Addendum No. 3

Project Title: C-418 Viewing Park Expansion

Project #: 2240980 Date of Addendum: May 7, 2025

VIEWING PARK EXPANSION CONSTRUCTION SAFETY PHASING PLAN

3 of 12

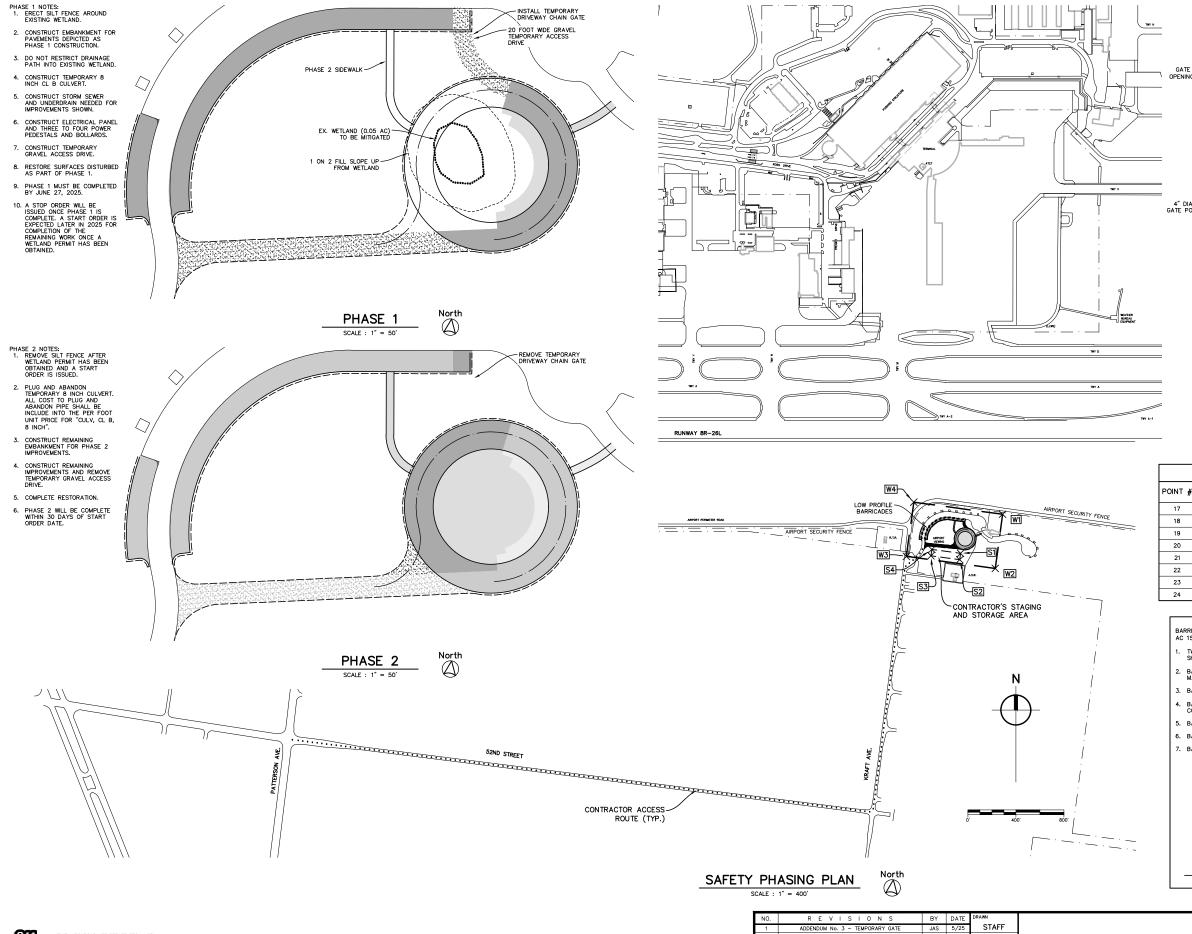
Sheet 3 of 12, Construction Safety Phasing Plan – Added location and detail for a gate across temporary driveway to be installed as part of Phase 1 and removed in Phase 2. Gate cost to be included in the item for "Safety and Security".

TEMPORARY DRIVEWAY - CHAIN GATE

ALL POSTS, HINGES, CLAMPS, CAPS, ETC. SHALL BE GALVANIZED. EYE BOLTS SHALL INCLUDE LOCKING WASHERS AND NUTS.

RED AND WHILE STRIPED SAFETY CHAIN MUST BE PERMANENTLY FIXED TO ONE POST. THE OTHER SIDE WILL BE CONNECTED USING A LOCK FURNISHED BY THE

ALL COSTS MUST BE INCLUDED INTO THE LUMP SUM UNIT PRICE FOR "SAFETY AND SECURITY". NO SEPARATE PAYMENT WILL BE MADE FOR THE TEMPORARY GATE.
